# Amendment Report

## Edge Estate

155-251 & 141-153 Aldington Road, Kemps Creek

SSD-17552047

Figure 9 Amended Site Plan

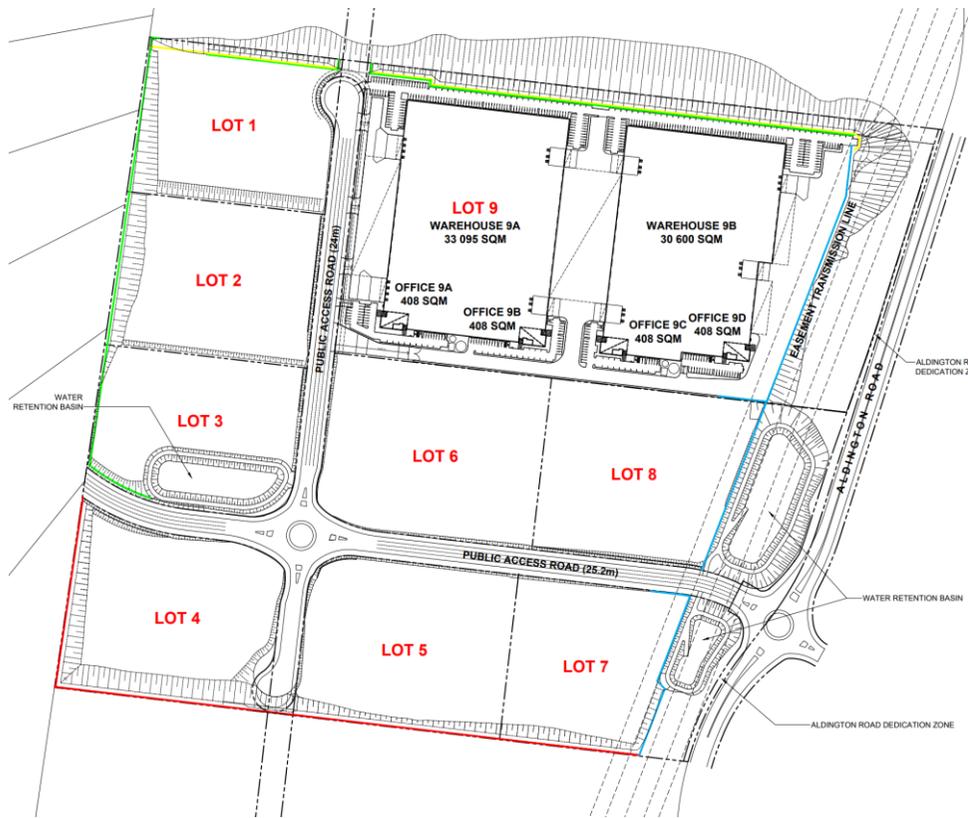
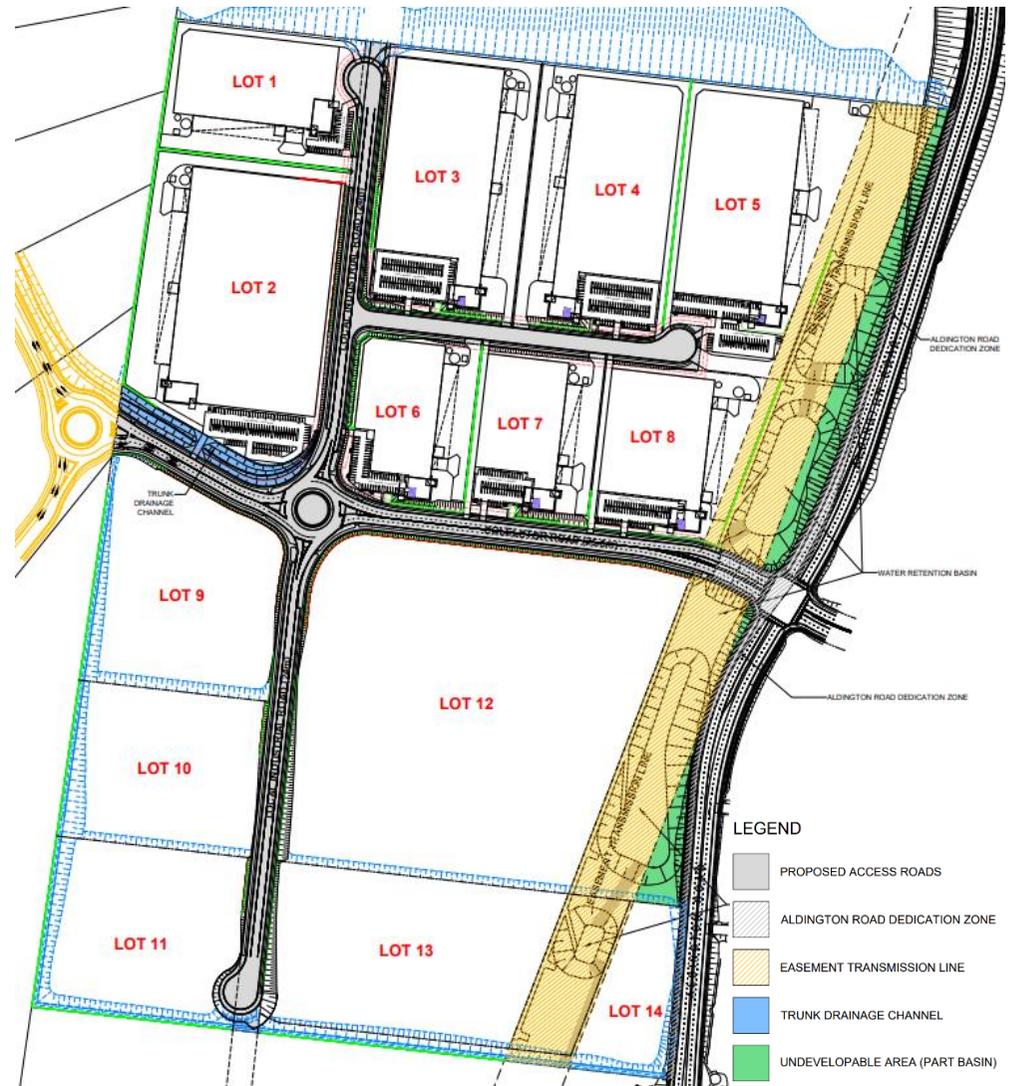
A comparison of the exhibited and amended site plan is provided in **Figure 8** and **Figure 9** on the following page.

**Figure 11 Amended Bulk Earthworks Plan**

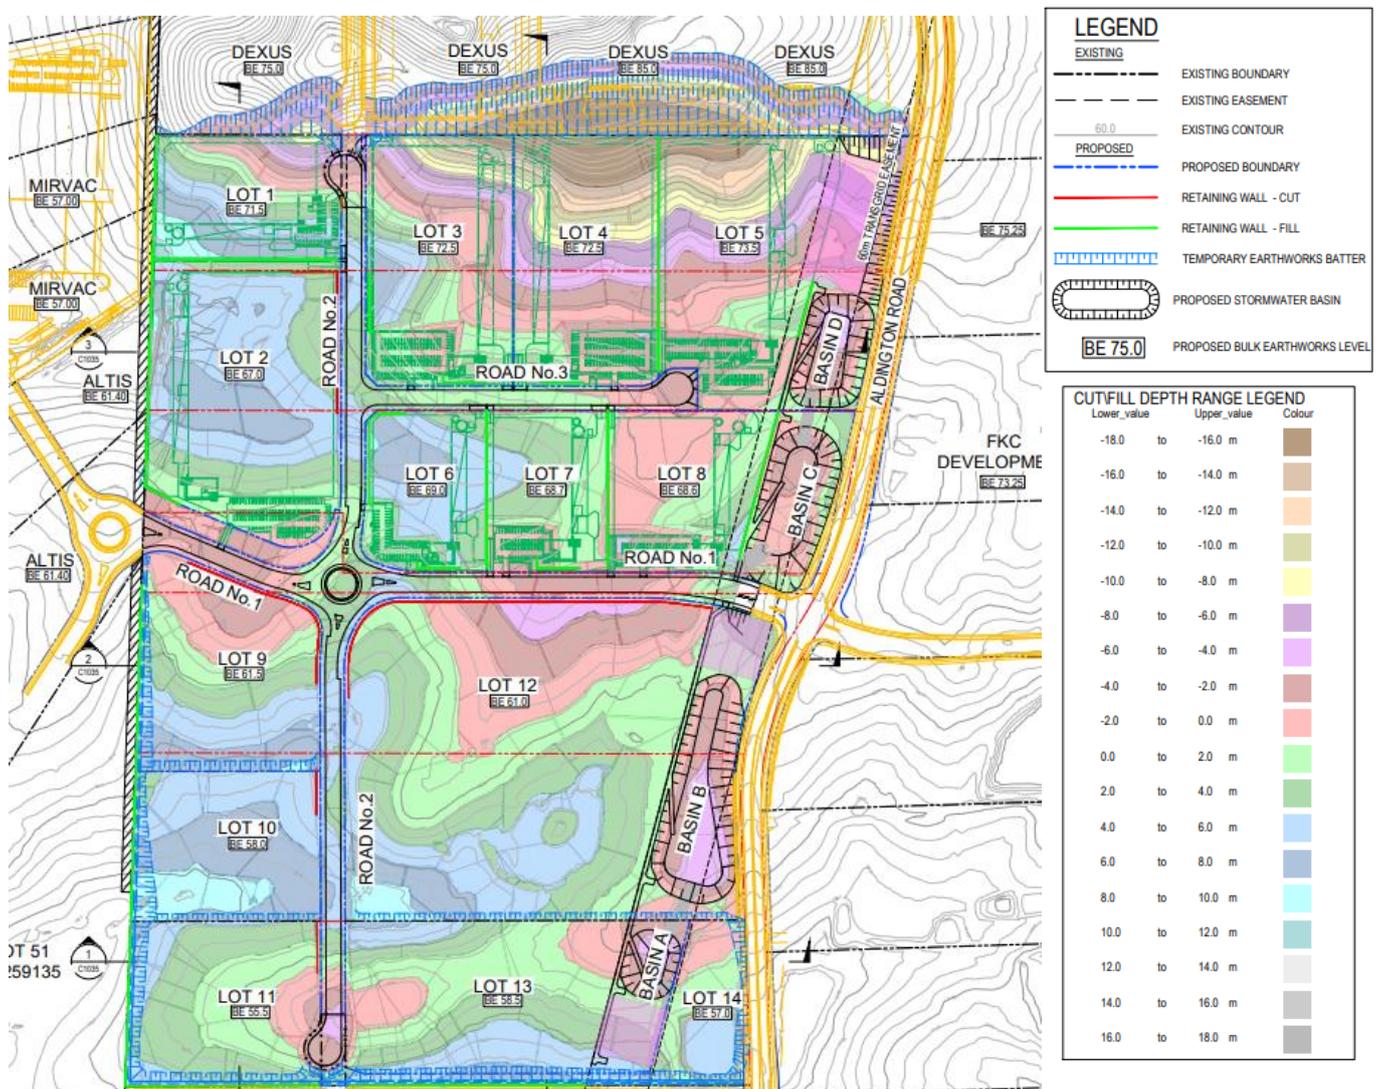
The amended development comprises configuration of the bulk earthworks as result of the inclusion of additional land and amendments to the proposed development. The amended bulk earthworks plan is provided in **Figure 11**, outlines the proposed cut and fill extent across the site as well as bulk earthworks levels.

**Figure 21 Amended General Arrangement Plan**

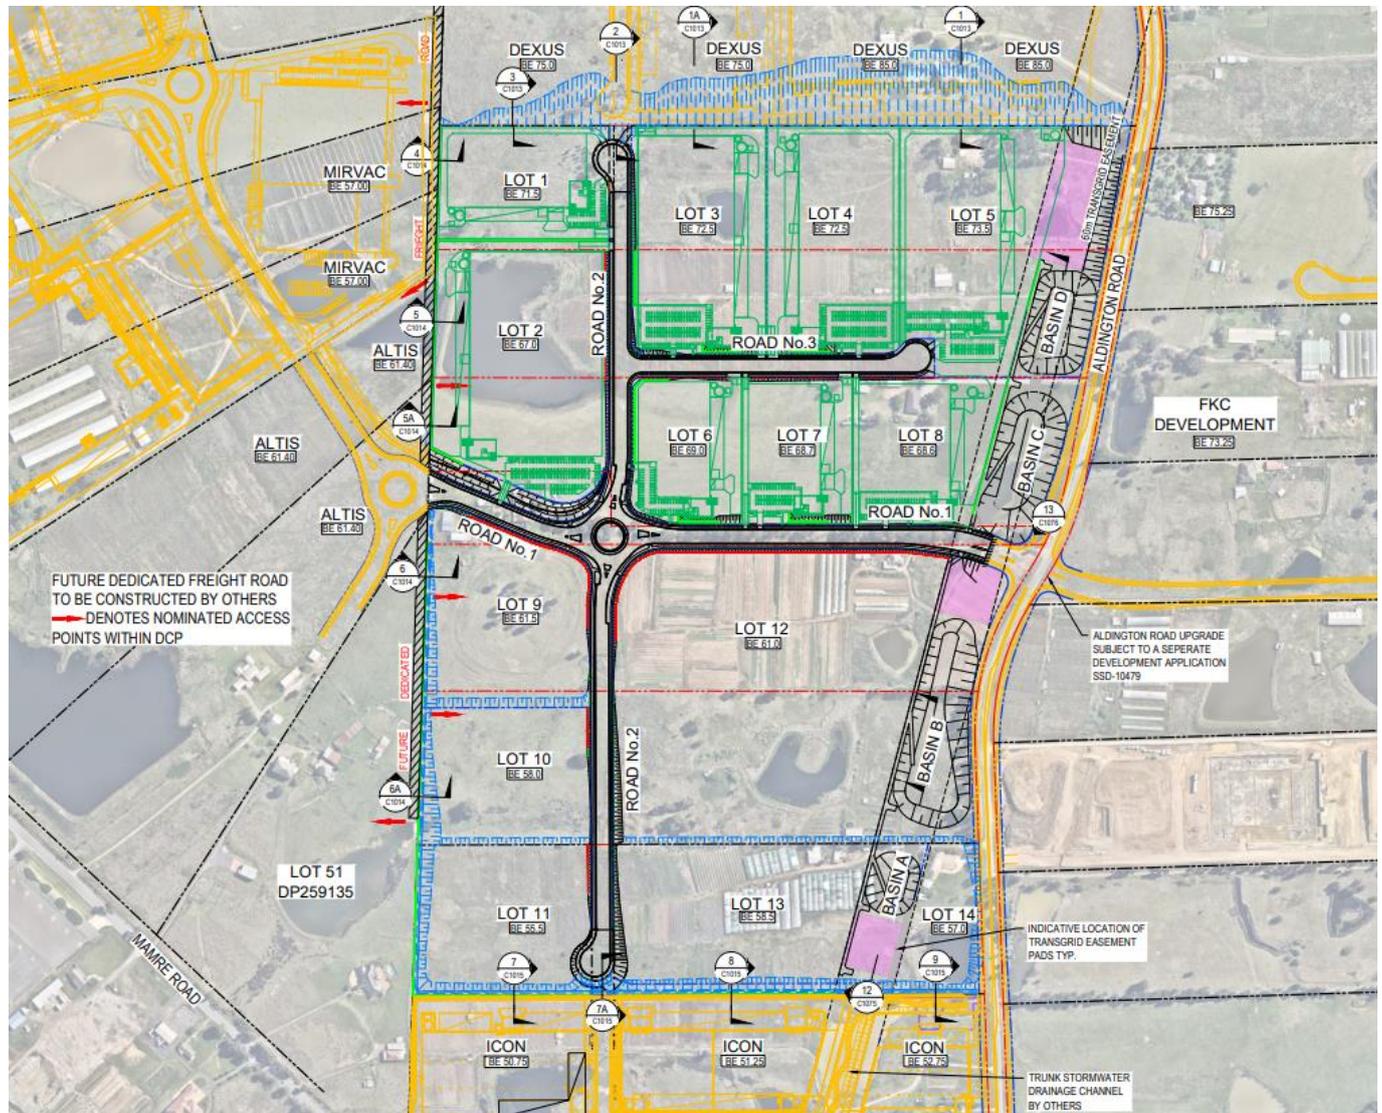
The internal road network (as illustrated in **Figure 21**) has been amended from the exhibited development to:

- Include an additional local industrial road (Road 3);
- Realign the western portion of Road 1 to reflect the amended roundabout location and design proposed by Altis under SSD-1764189; and
- Extend Road 2 further south to the amended site boundary.

**Figure 22 Road 1 – Typical Section**

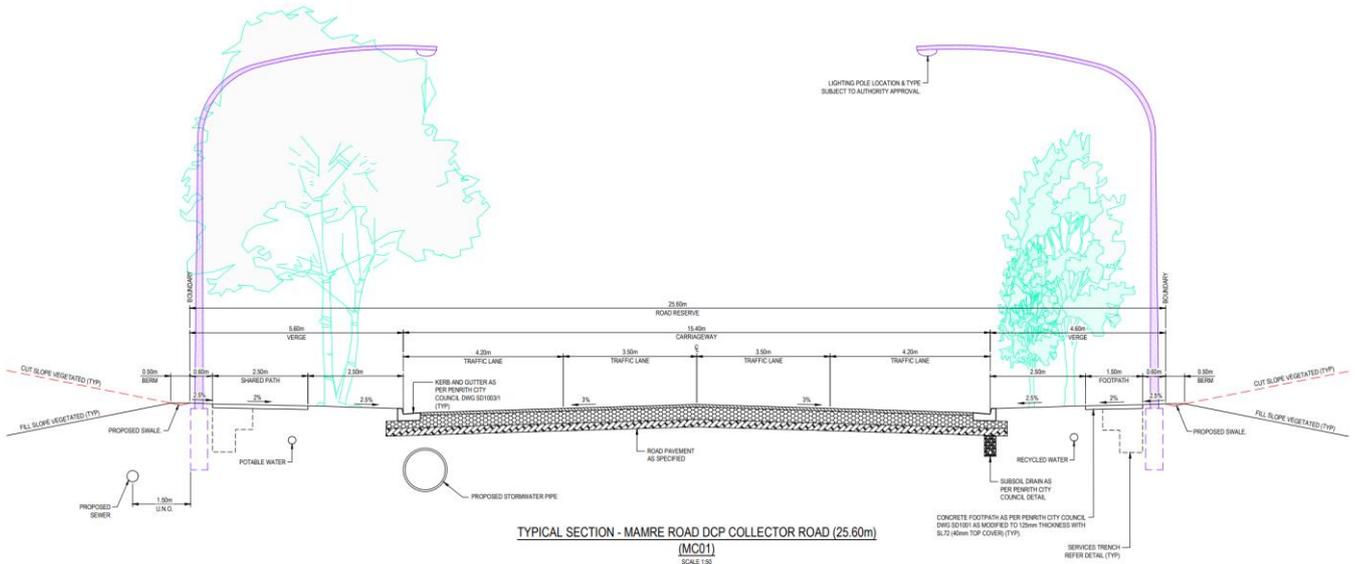
- Road 1 has been amended from 25.2m to 25.6m in width as a result of an increase in the parking lane by 0.2m on each side; and
- Road 2 remains substantially the same with only minor changes to the street reserve gradient.

**Figure 43 Amended General Arrangement Plan**

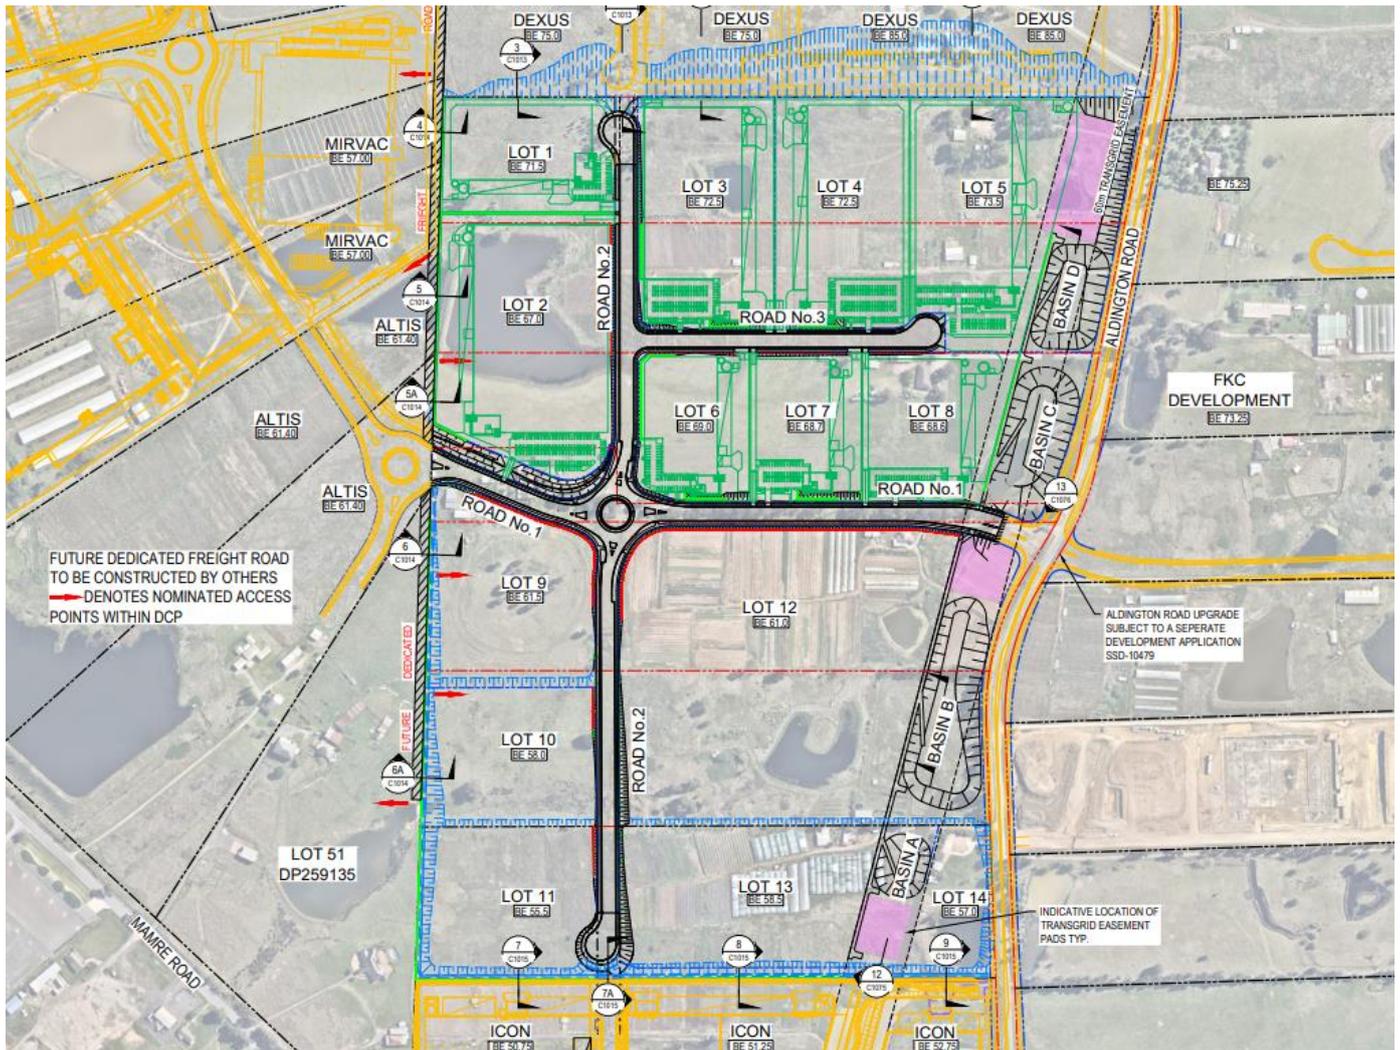
The proposed detention basins connected via culvert pipes are supported by Transgrid as they allow for the provision of structure pads for transmission line towers approximately every 400m (refer to the pink shaded areas in **Figure 43**). Correspondence with Transgrid is provided at **Appendix MM**.

The proposed location of the western trunk drainage line (refer to **Figure 43**) represents a significantly better outcome than the indicative location under the MRP SSP. The proposed location enables the trunk drainage line to be located adjacent to Road 1 which results in public infrastructure being located adjacent to each other, providing easier access for maintenance. It also provides a setback from Road 1 to the proposed Warehouse 2 (Lot 2), which with the proposed landscaping, will form a landscape buffer. It also enables a more efficient development layout that provides greater warehouse floorspace contributing to employment generation, the objectives of the MRP and constitutes orderly and economic development under the objects of the EP&A Act.
